TECHNICAL SERVICE BULLETIN

Non-Hybrid - Radio Static And/Or Poor Radio Sound Quality When Moving

22-2040

| Ford 2020-2022 Explorer | Non-hybrid |

Figure 1

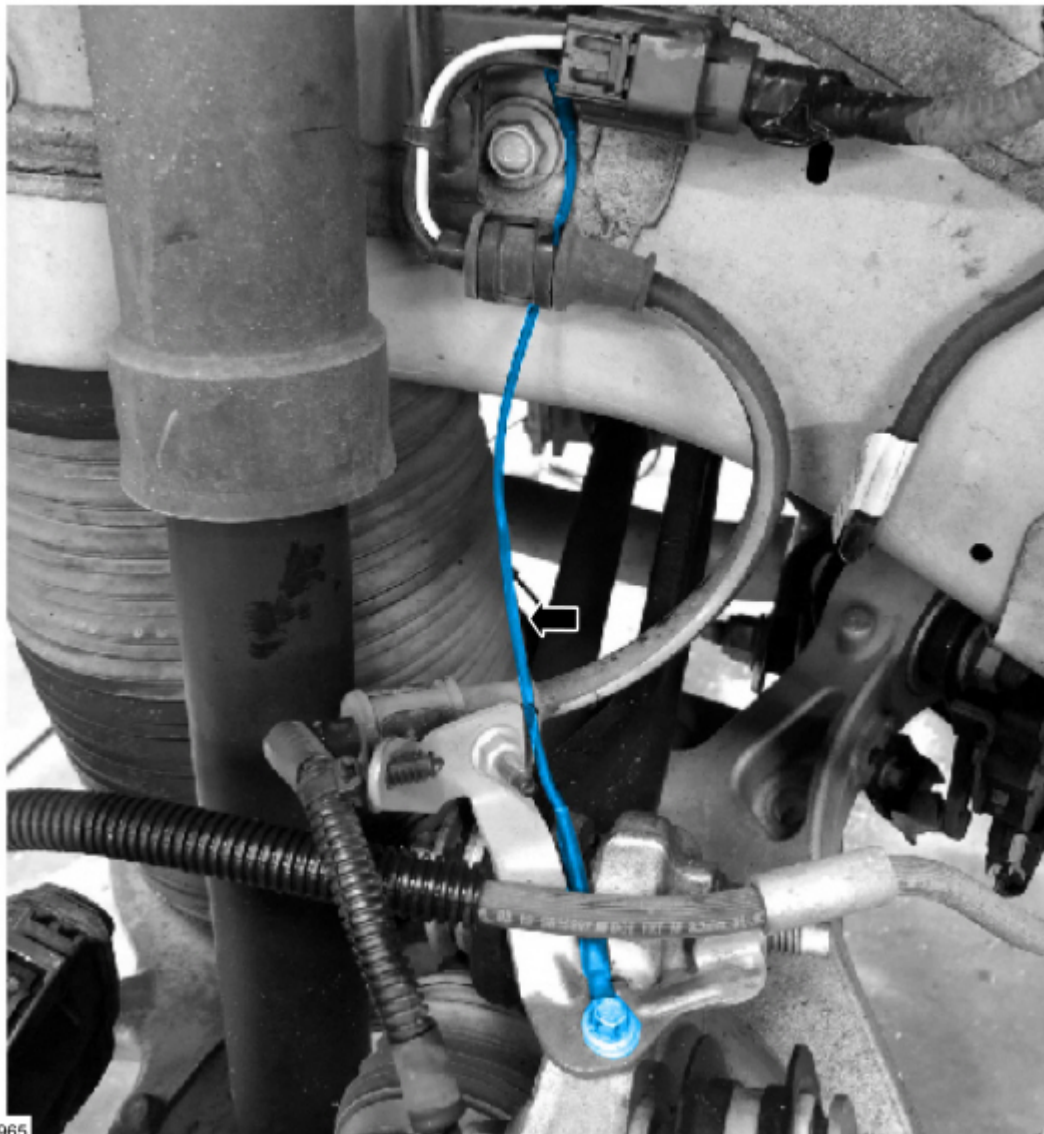
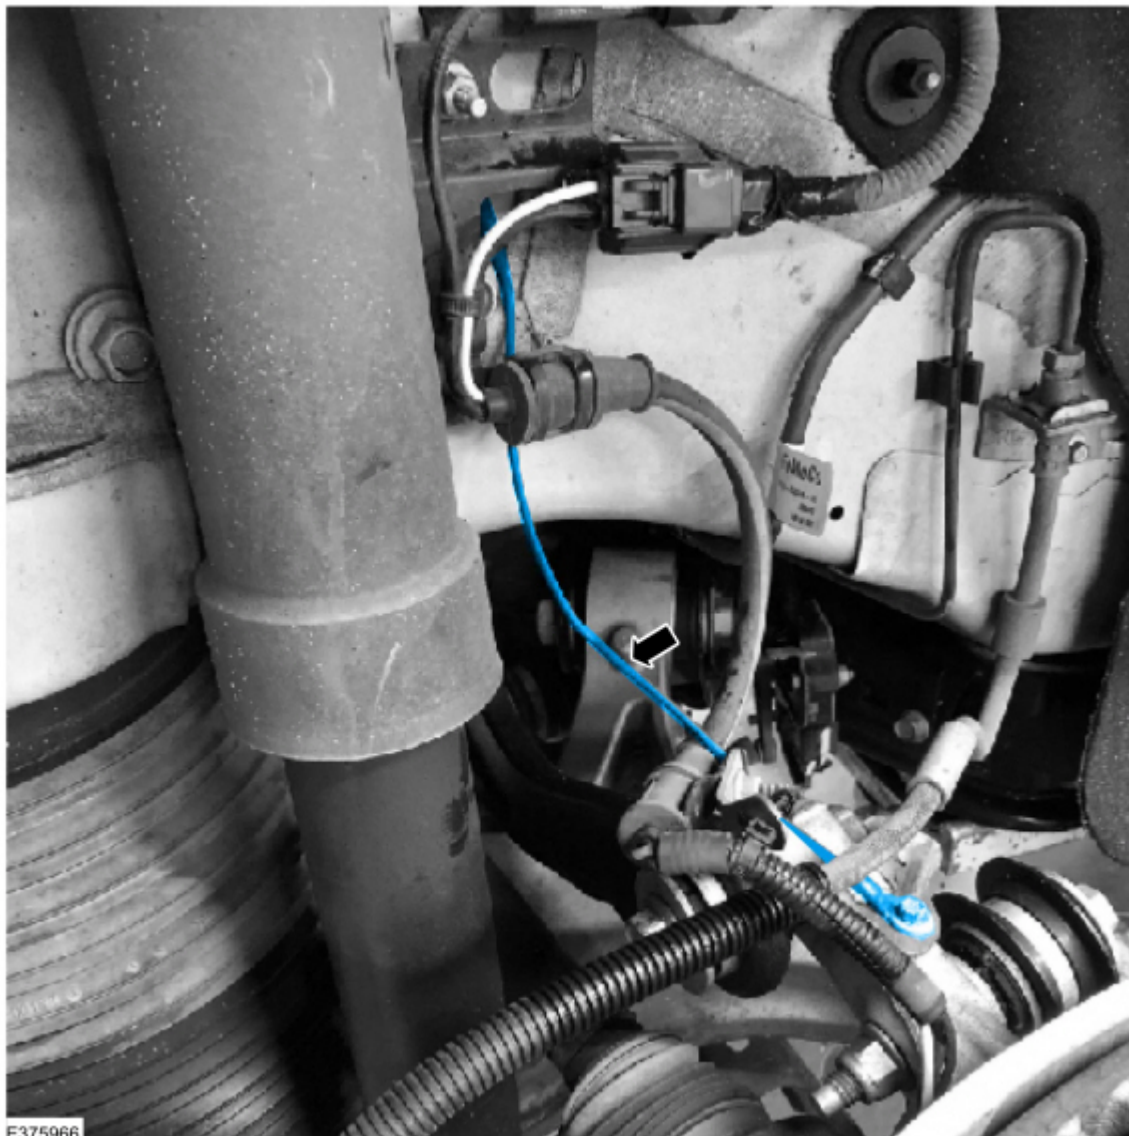
Issue: Some 2020-2022 Explorer/Aviator non-hybrid vehicles may exhibit radio static and/or poor radio sound quality when moving. This may be more noticeable on AM radio stations. This may be caused by an electromagnetic interference concern. To correct the condition, follow the Service Procedure to install new grounds on the rear knuckle.

1. Install new ground straps on each side of the vehicle on top of the brake hose bracket bolt on the rear knuckle. Tighten to 133 lb-in (15 Nm). Refer to Workshop Manual (WSM), Section 204-02. (Figures 1-2)

2. Install the other side of the ground straps underneath the rear wheel speed sensor harness bracket mounting stud. Tighten to 62 lb-in (7 Nm). Refer to WSM, Section 206-09. (Figures 1-2)
